Proposed Tiger Crossings, Haverhill, Suffolk

Stage 1 Road Safety Audit

Reference: PB8301_HTC_RSA1_F01

Date: 24 March 2020

Extracts from drawing PB8301-RHD-DE-HI-DR-D-0150, showing absence of deflection on approach to the Tiger crossing for cyclist

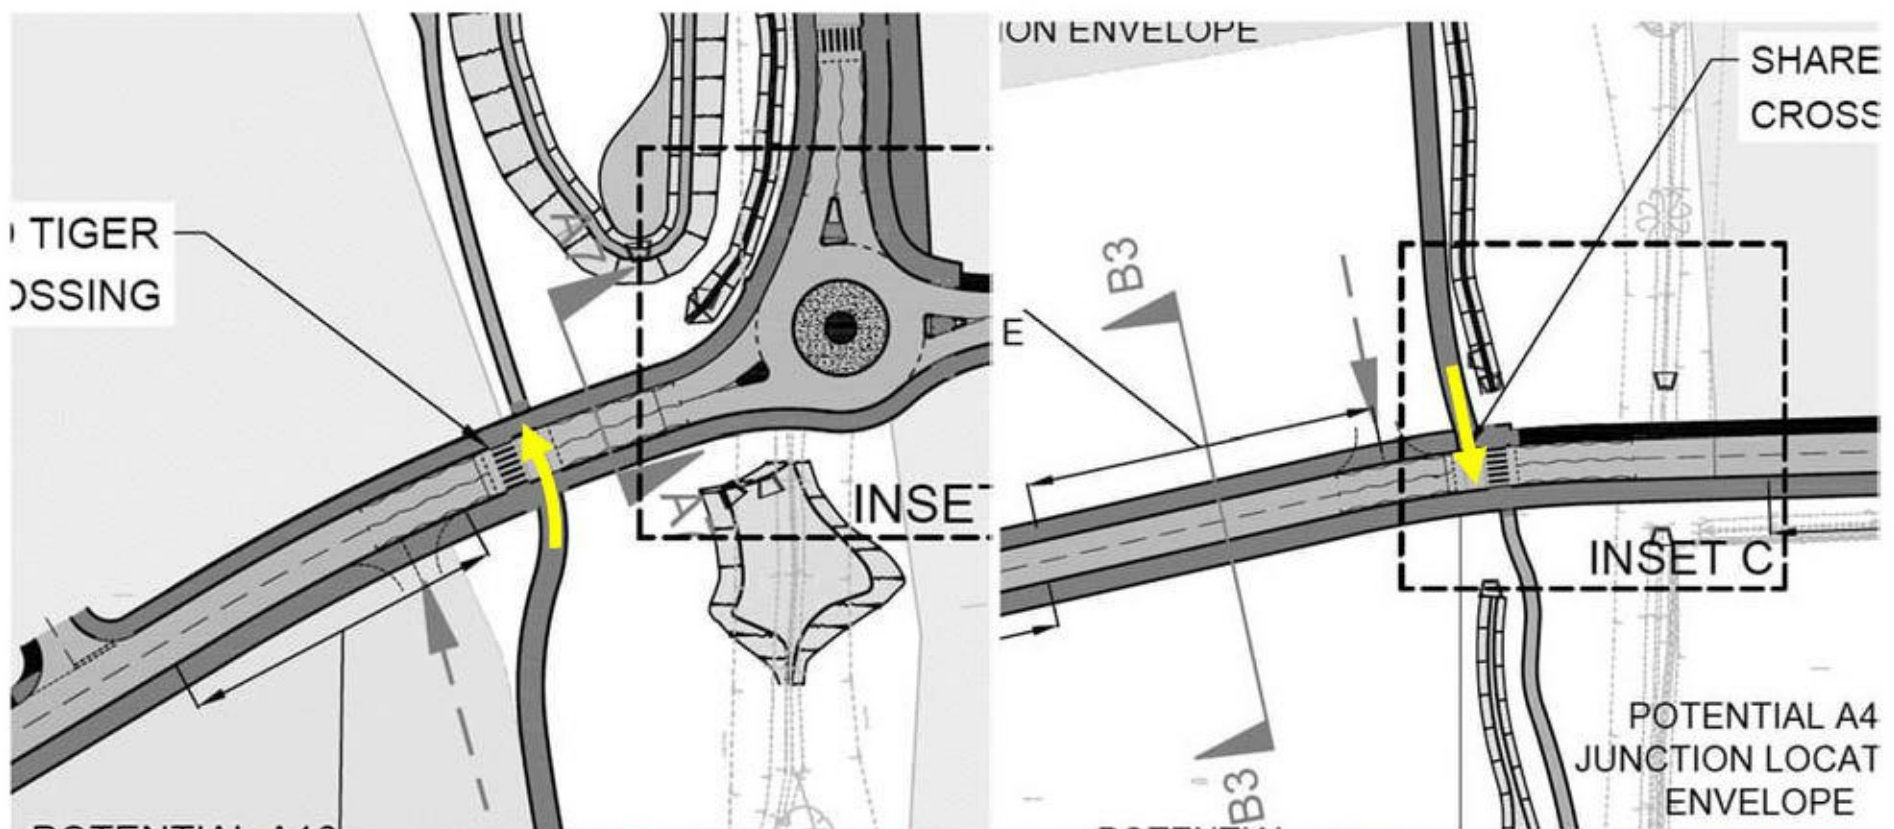
A4.1.2 Problem 3

Location: Footway/ cycleway approach to proposed Tiger crossing (shown at western extent of Inset A, on Inset C and at the south-eastern extent of drawing PB8301-RHD-DE-HI-DR-D-0150).

Summary: Absence of deflection on approach to the cycle crossing element of the proposed Tiger crossing could result in inappropriate cycle speeds, leading to collisions between road users or sudden braking and rear end shunts on the main road.

Description: No deflection or deviation of the footway/ cycleway approach to the Tiger crossing has been provided. The cycle element of the Tiger crossing is directly in line with the footway/ cycleway, which allows cyclists to approach and enter the crossing at speeds. Drivers on the main road may brake sharply upon seeing a cyclists approaching the crossing at speed, resulting in rear end shunts.

Furthermore, cyclists approaching the crossing at speed may be unable to slow/ stop sufficiently before entering the carriageway, resulting in collisions with road users on the main road.

RECOMMENDATION

Provide deflection on approach to the Tiger crossings to slow cyclists as they approach the facilities. If it is not possible to provide adequate deflection, measures such as bollards or 'SLOW' markings should be installed. The installation of any bollards should consider the footway width requirements of wheelchair users and those pedestrian with additional mobility requirements, such as those with pushchairs/ walking frames.

In conjunction with the above, sufficient forward visibility should be provided on the deflected approaches to the Tiger crossings from the footway/ cycleways, increasing intervisibility between all road users.

TITLE	PROJECT
PROBLEM LOCATION PLAN	PROPOSED TIGER CROSSINGS, HAVERHILL STAGE 1 ROAD SAFETY AUDIT

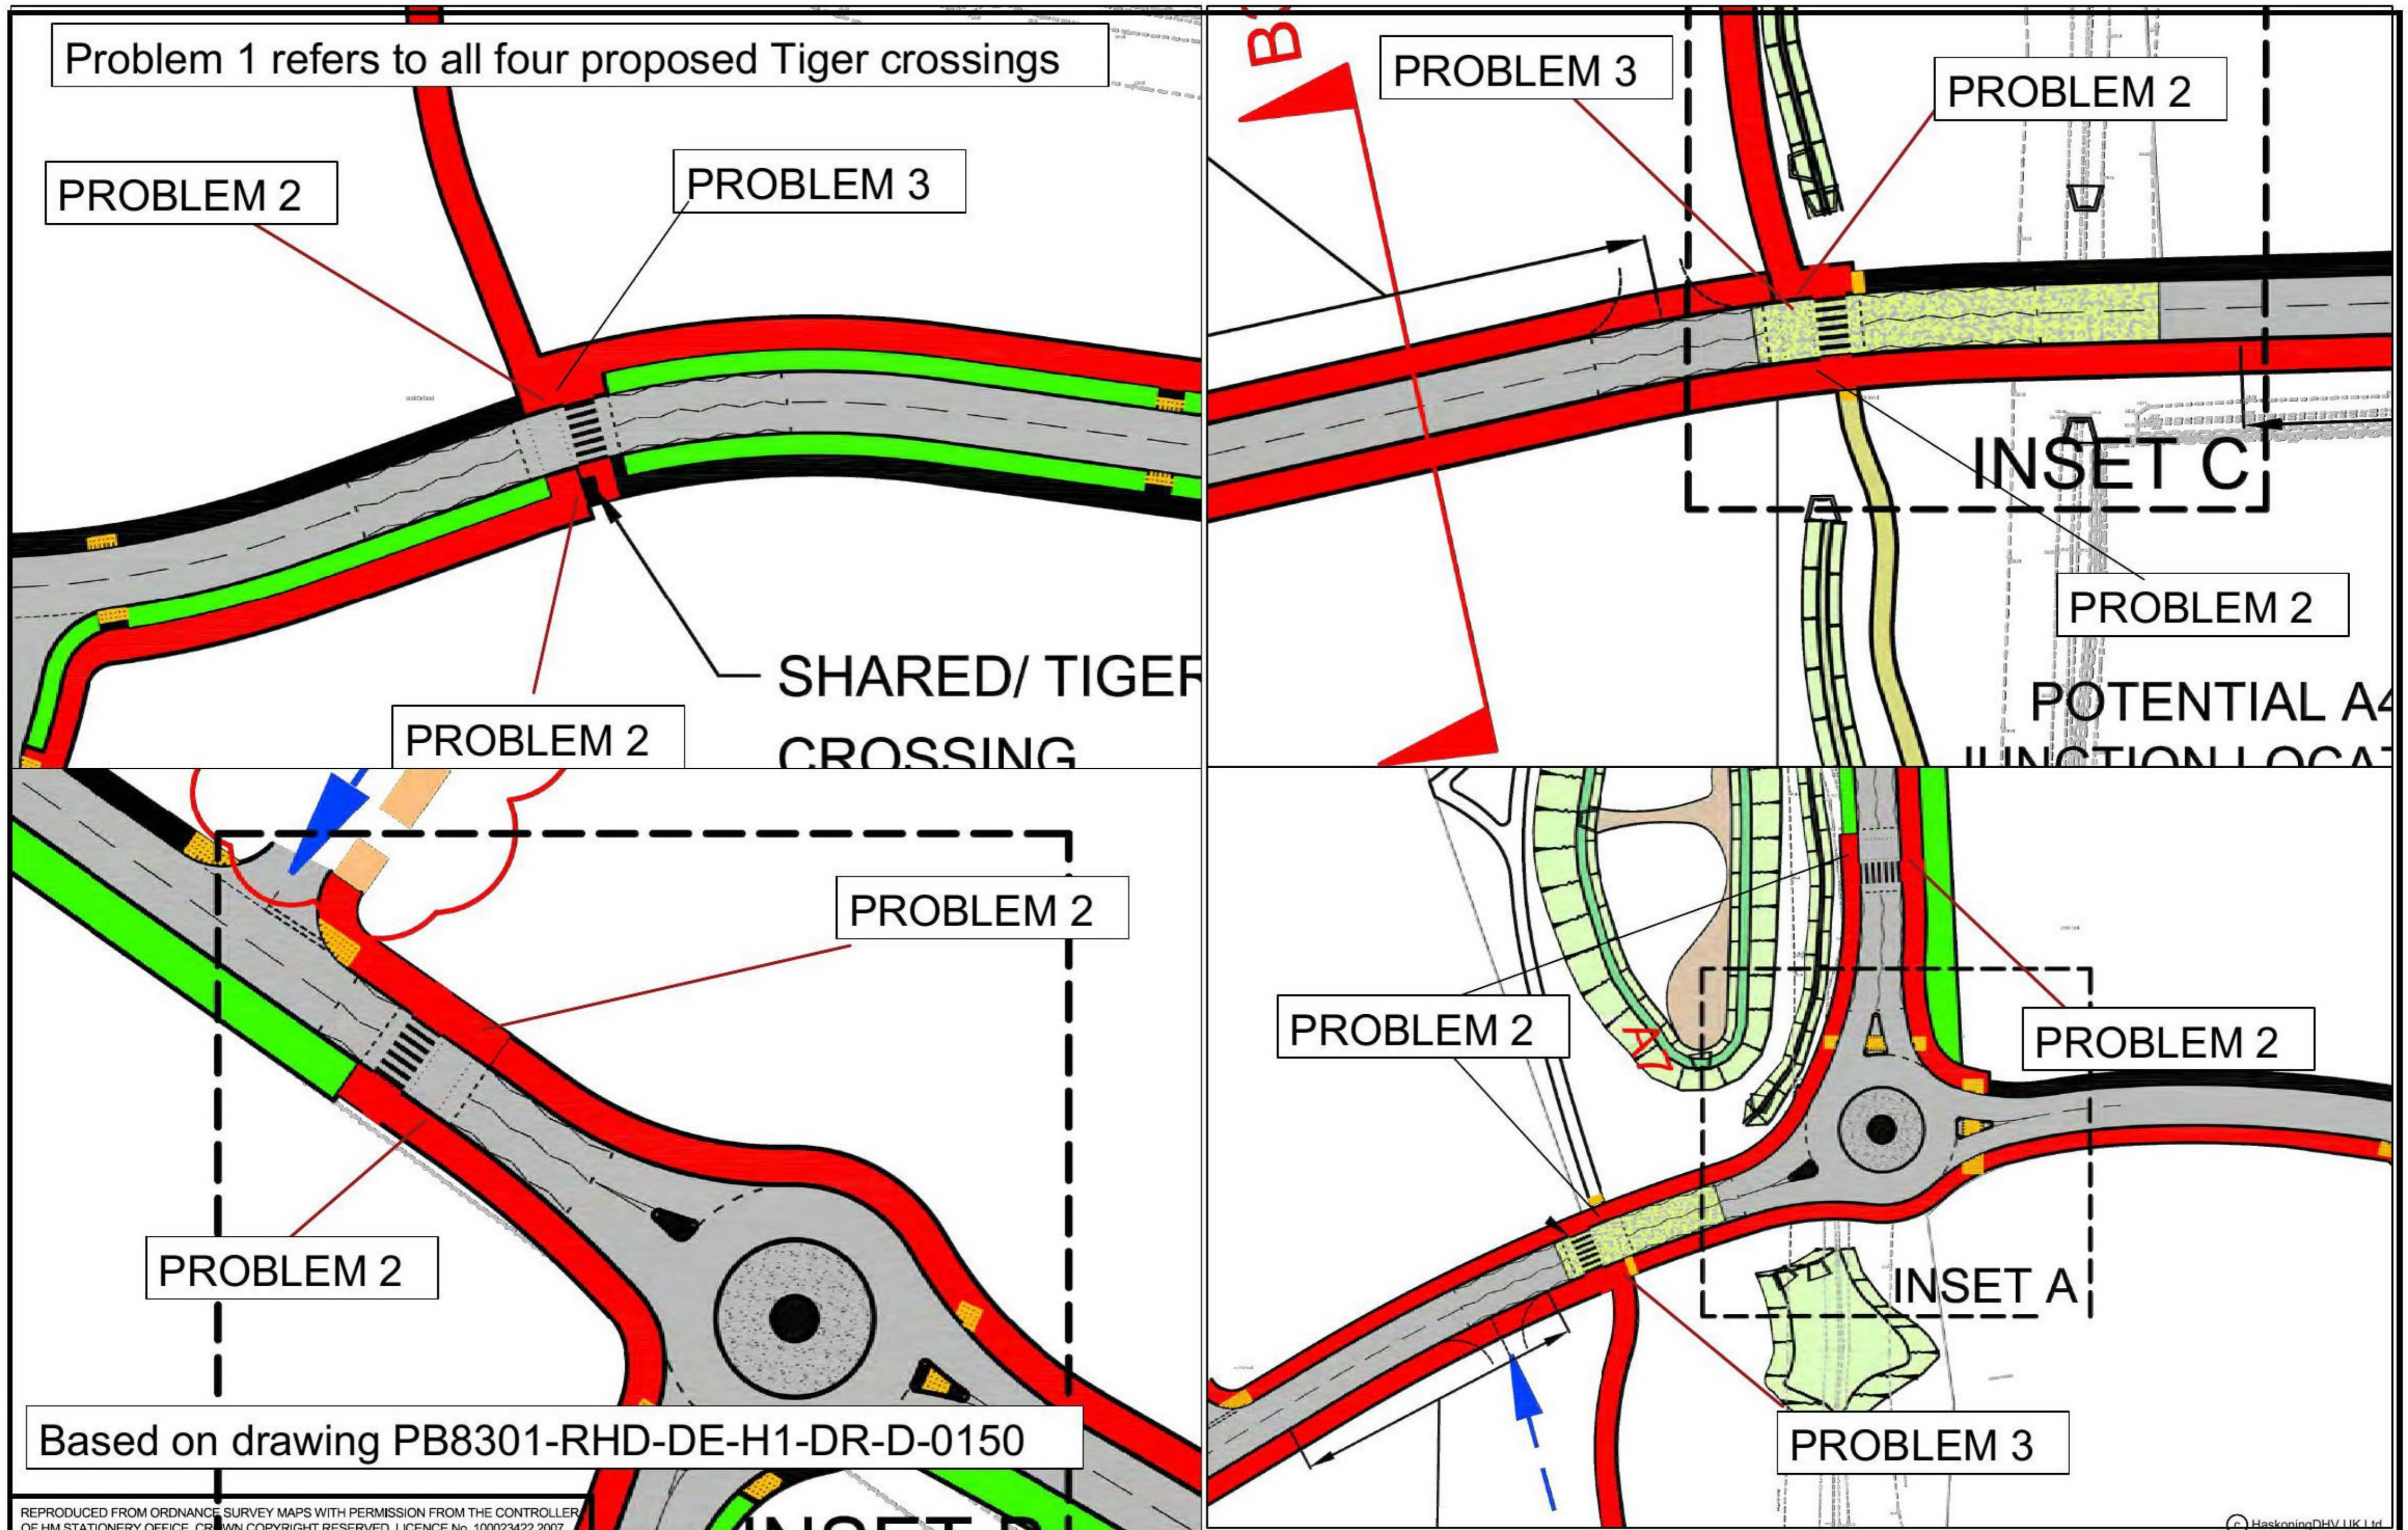
A2.1.1 Problem 1

Location: Proposed Tiger crossings.

Summary: Inappropriate vehicle speeds on approach to the Tiger crossings could result in sudden braking and rear end shunts or to crossing overshoot, leading to collisions with pedestrians/ cyclists.

Description: The proposed Tiger crossings adjacent to Inset C on Drawing PB8301-RHD-DE-HI-DR-D-0150 and to the south-east of the scheme are located on relatively long, straight sections of highway, which could result in high vehicle approach speeds. Inappropriate vehicle approach speeds could result in sudden braking and rear end shunts or to collisions with pedestrians/ cyclists on the crossing.

Whilst the remaining three crossings are situated adjacent to roundabouts, one the inbound approaches are also after relatively long straight sections.

The Audit Team acknowledge that accesses associated with future development could increase activity on the proposed highway approaches to the Tiger crossings, potentially leading to reduced vehicle speeds. However, during off-peak traffic periods vehicle speeds could be inappropriate and, as such it is recommended that the Tiger crossings are situated on raised tables, or humped, slowing traffic on the approach and reducing the potential for sudden braking or collisions with pedestrians/ cyclists on the crossings.
